**SUPPLEMENTAL INFORMATION**  
**ADDENDUM NO. 2**

PROJECT: RFQ No. 20-29-004 – Sandhill Recreation Complex - Upgrades

DATE ISSUED: January 15, 2020

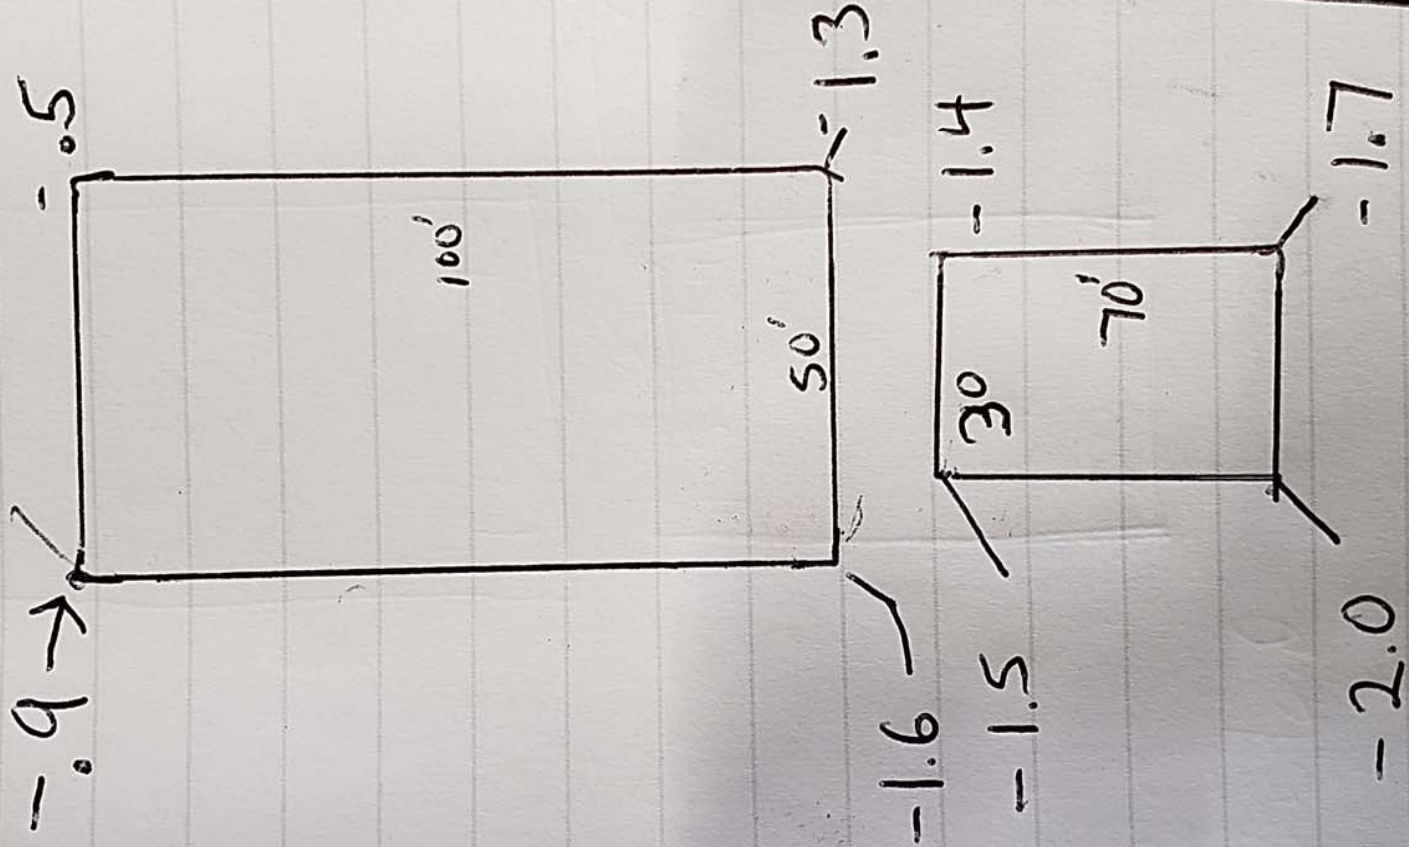
- 4) QUESTION: Greg said he had spoken with one of the staff about not being able to put the batting cages butted up to one another side by side. Two options of either

have space between the two cages or the slab would have to be bigger than the specified 30'-0", possibly 35'-0"

ANSWER: Batting cages will be side by side with a possible 4'-8' distance between them. This space will not be concrete.
